Product Change Notification

Product Change Notification: E-21-003104

T9A series relay

Marking change compare

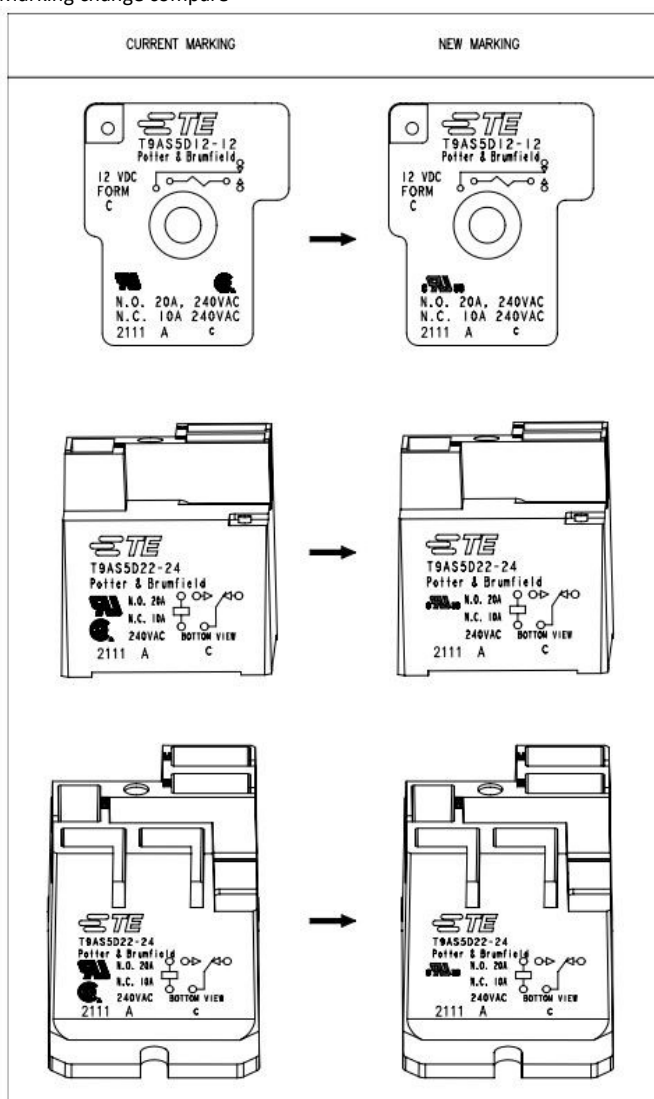
Change UL agency approval mark from RU to cRUus, and remove CSA mark. Product still meet two standards UL508 and CSA C22.2 NO.14-13. no any function and performance change, only appearance marking change.
